**INSPECTION NOTE OF PENCH DIVERSION
PROJECT BY E-IN-C, W.R.D., BHOPAL, DATED
19.06.2016**

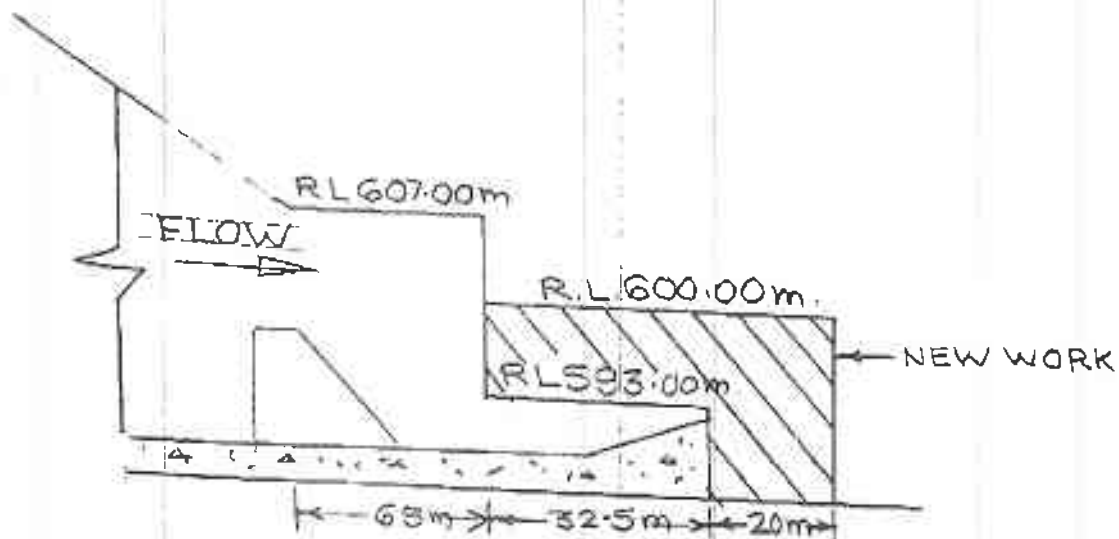
Concrete Dam :- The following works in concrete dam are to be done:-

- i. Second stage concreting;
- ii. Power pack rooms.
